4 November 2020

Tahmoor South Project: Response to Request for Information No. 3

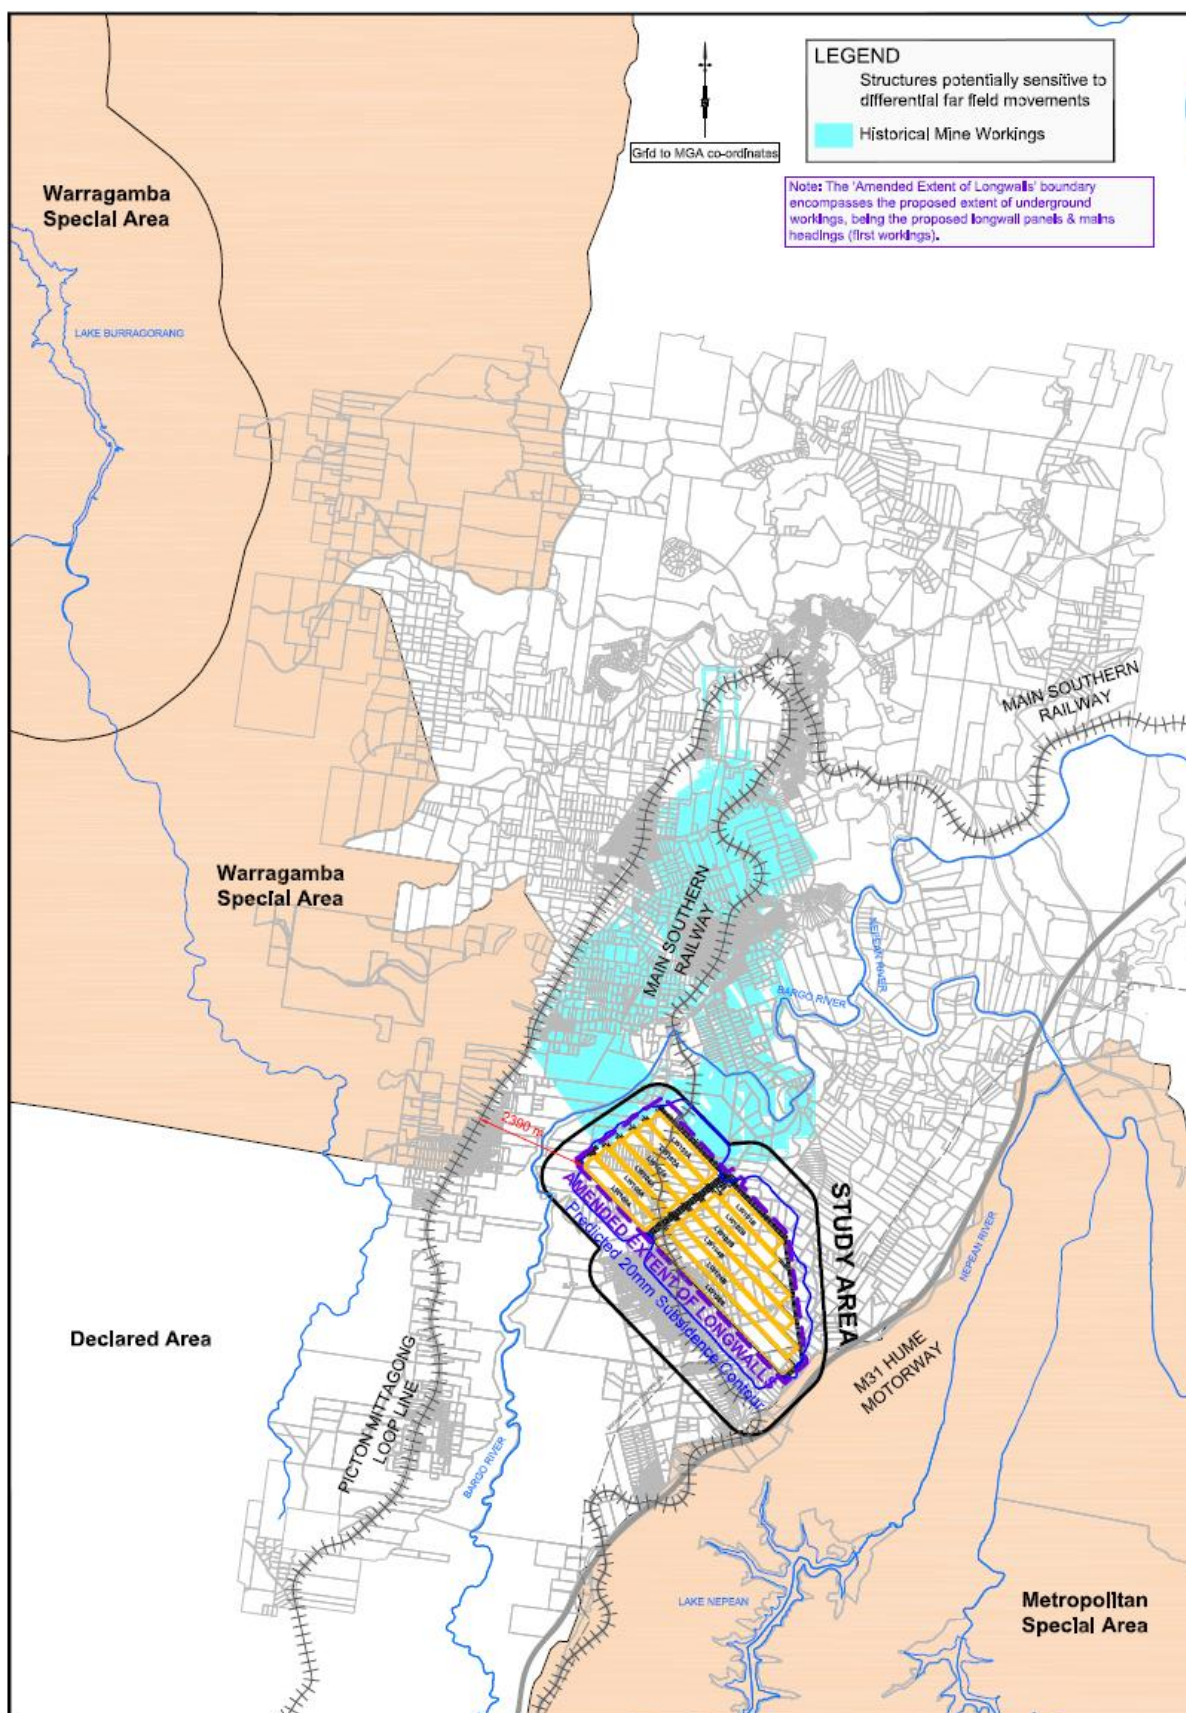
1. Project application area in hectares (ha).
2. Area (in ha) of the existing surface facilities site.
3. Distance between the Warragamba Special Area and the nearest proposed longwall panel.

1. The project application area is 6,490 hectares.
2. Mining Lease (ML) 1642 covers the surface facilities area, as shown on Figure 1.3 of the EIS (AECOM 2018). ML 1642 covers an area of 206.38 ha.
3. The distance between the Warragamba Special Area and the nearest longwall panel is 2,390 metres. A figure illustrating this distance is provided on the following page.

Tahmoor South Project
Noise and vibration impact assessment
Figure 2

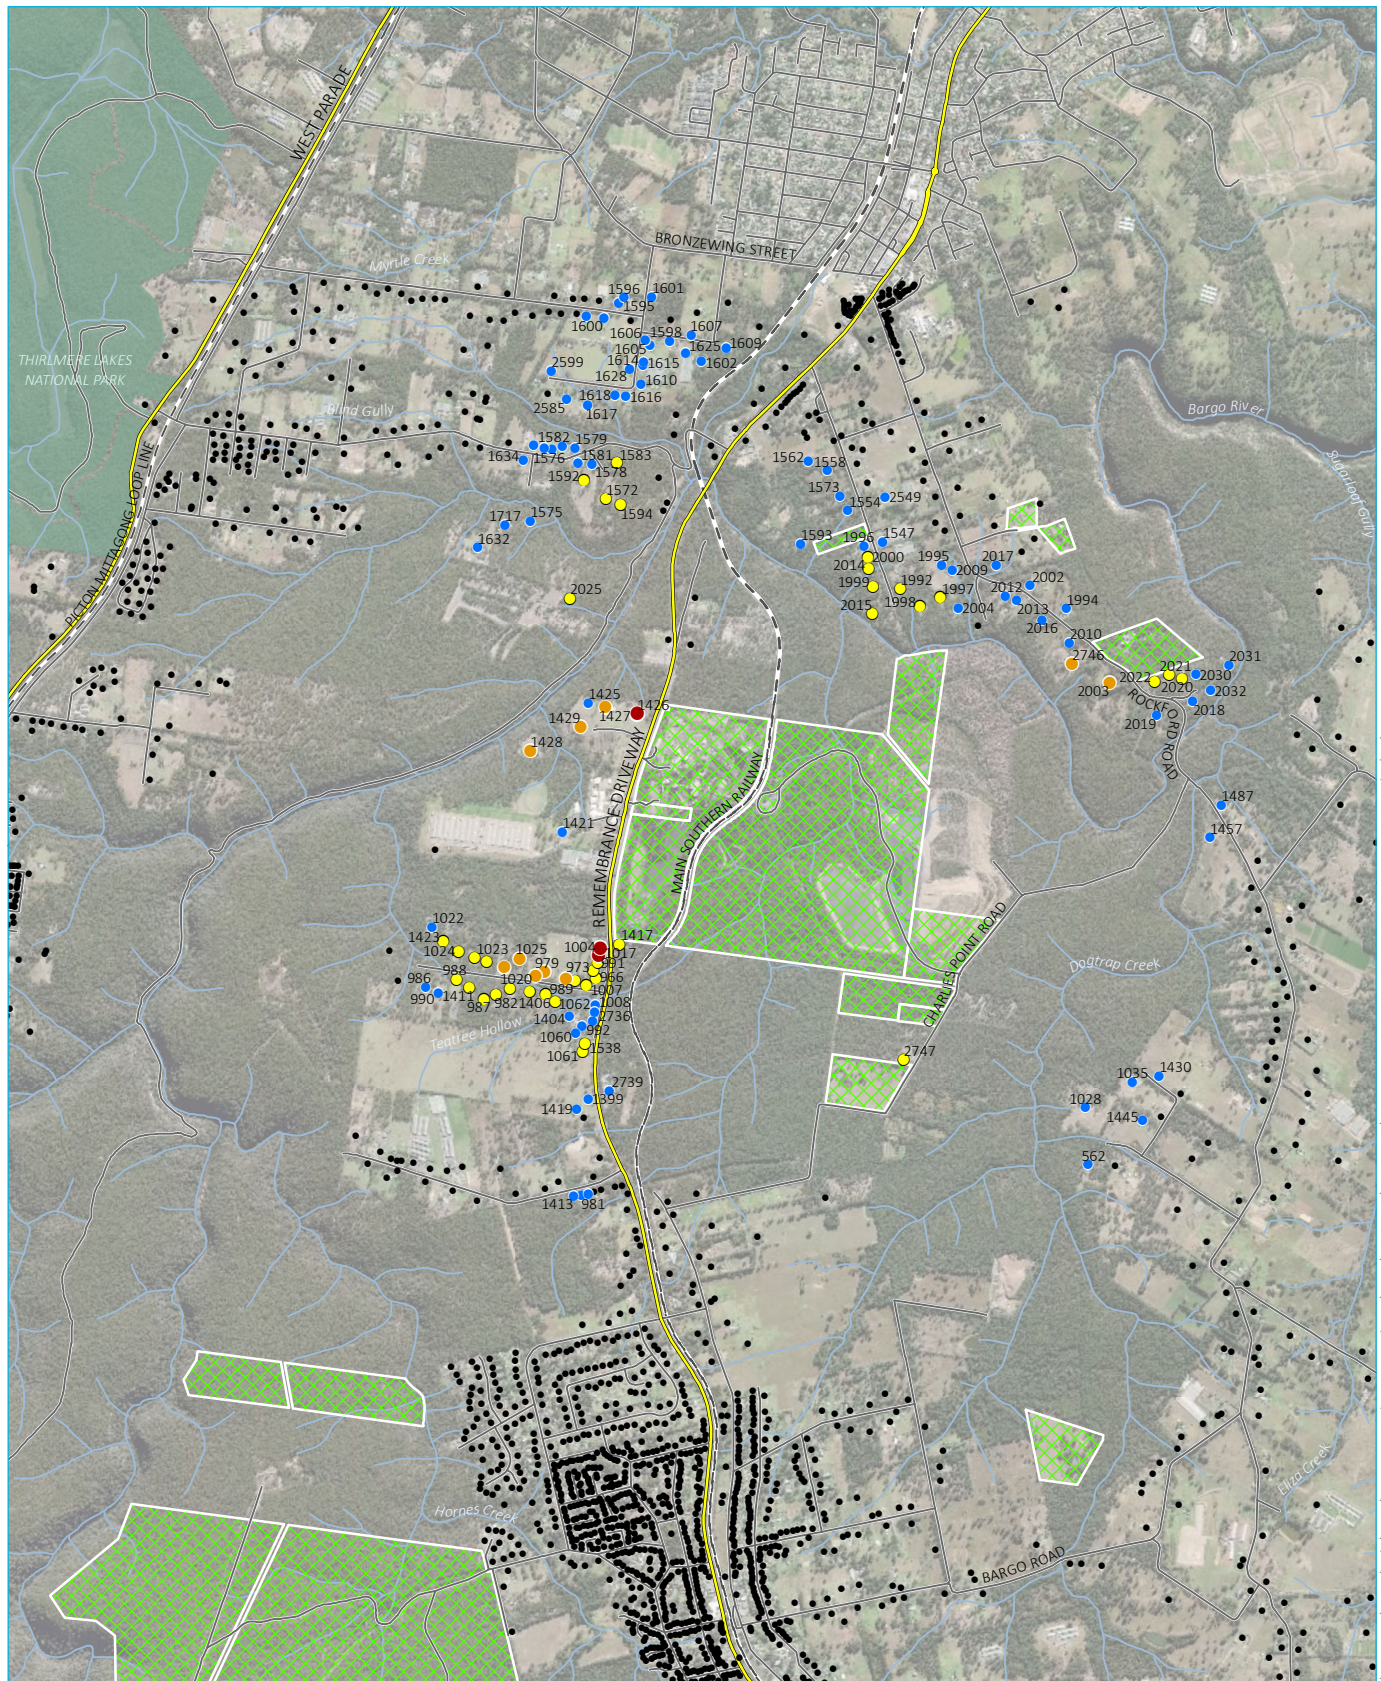
4. Figures:
 - a. Update Figure 2 of the *Response to Request for Information No. 2* to include receiver numbers and noise level contours.
 - b. Consolidate Figures 3,4,5 of the *Response to Request for Information No. 2* into one figure that depicts the worst-case noise emissions for the project under the mitigated scenario. Please include receiver numbers and noise level contours.

- An updated Figure 2 is included over the page, presenting receiver numbers.
- Figure 6 of the Response to Request for Information No. 2 provides the predicted, worst-case residual noise impacts of all stages under the mitigated scenario. This figure has been updated to include receiver numbers.
- Figure 7 has been updated to include noise catchment areas.

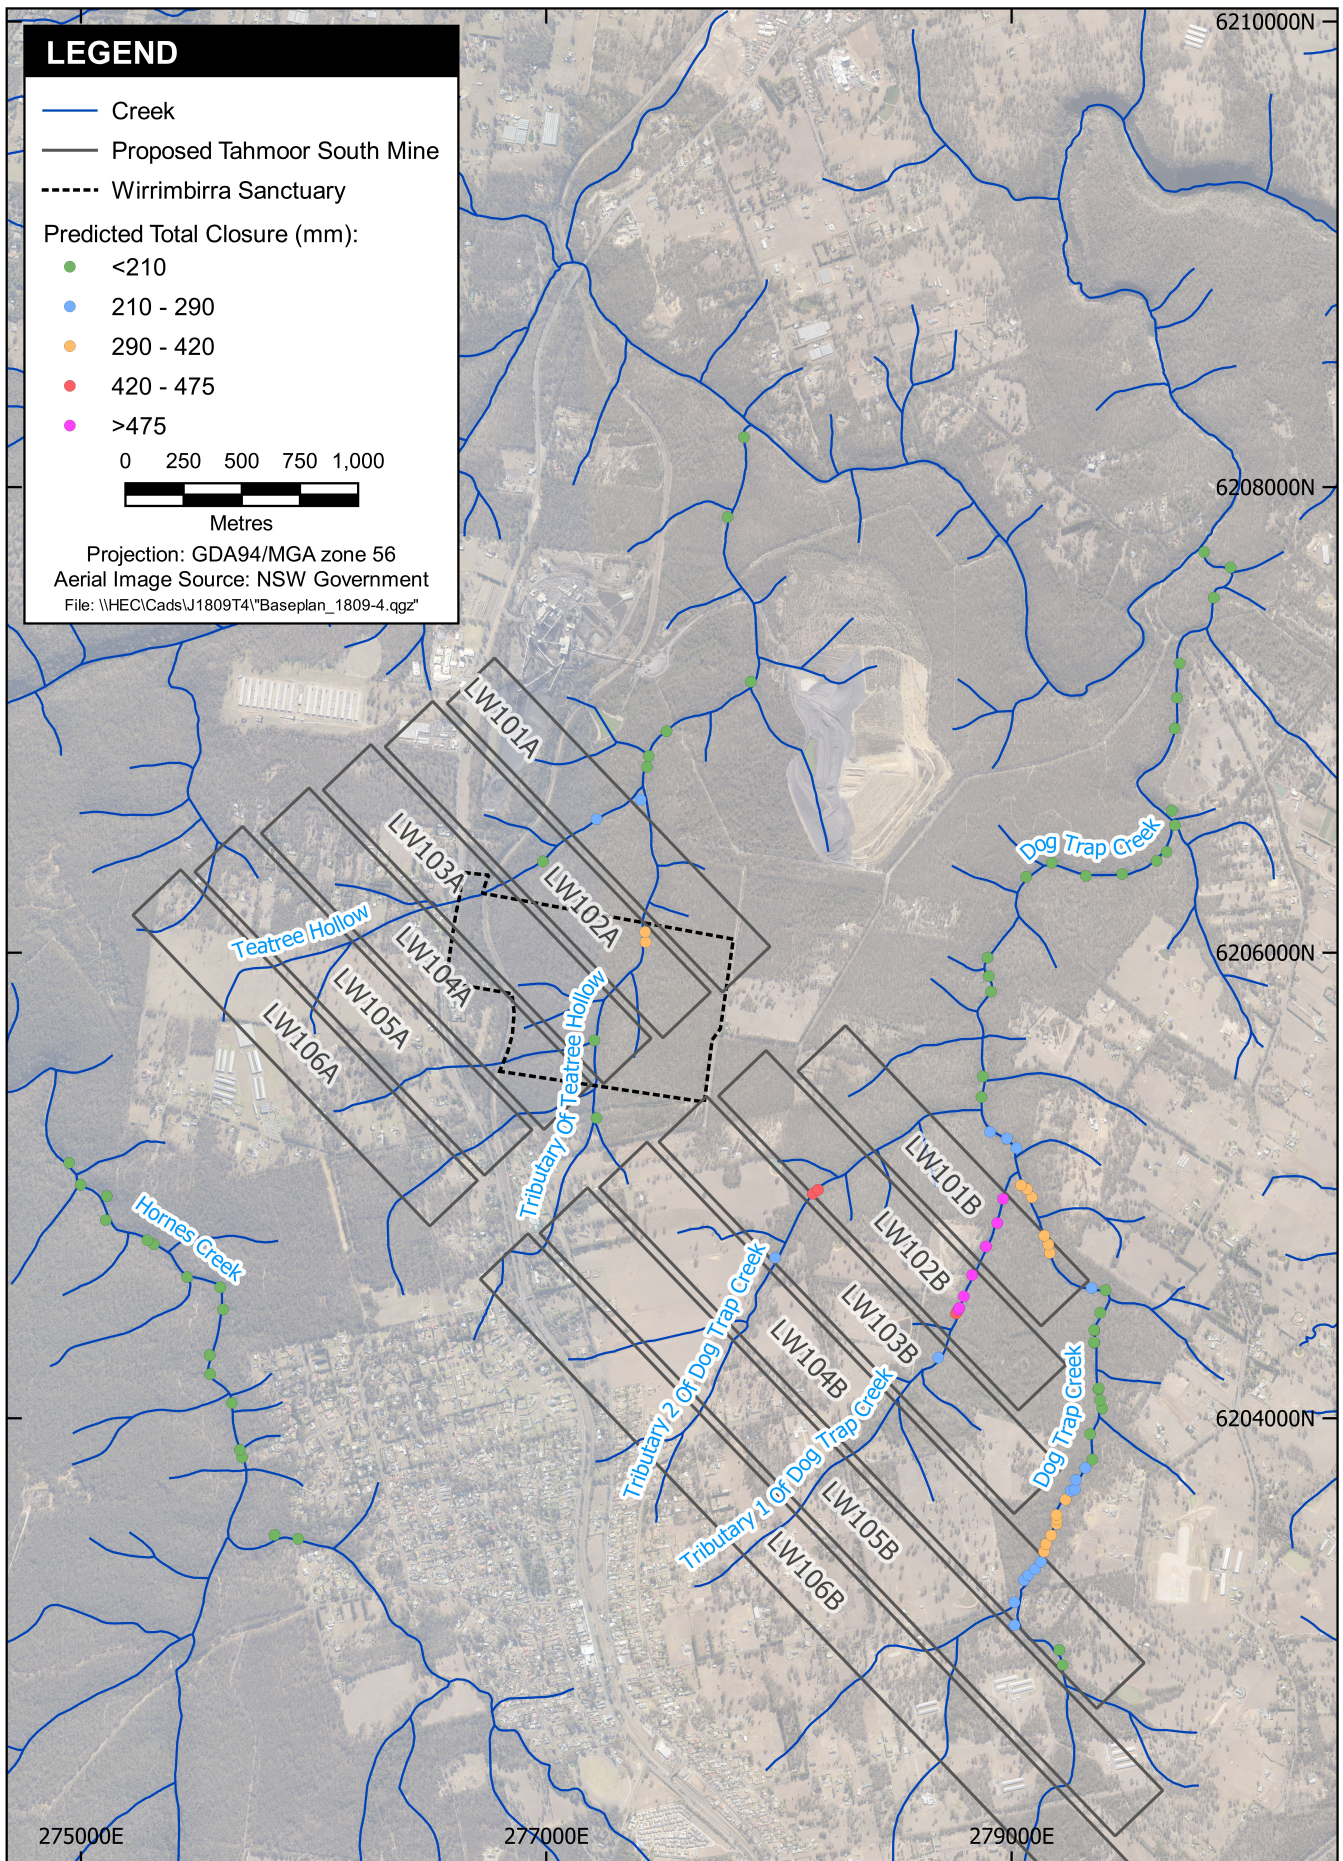
1. High resolution copy of the location of pools figure on page 14 of the *Response to Request for Information No. 2*.
2. Update of Figure ES2 of the Second Amendment Report to show the surface facilities site, REA and vent shaft sites.
3. A figure to show the existing and proposed layout of the surface facilities site (including all key infrastructure and proposed site entrance intersection upgrade), REA (including extension staging areas) and vent shaft sites (including associated transmission lines).

1. A high resolution copy of the location of pools figure is provided over the page.
2. A revised figure ES2 is included over the page.
3. The requested figures showing surface facilities are provided over the page.
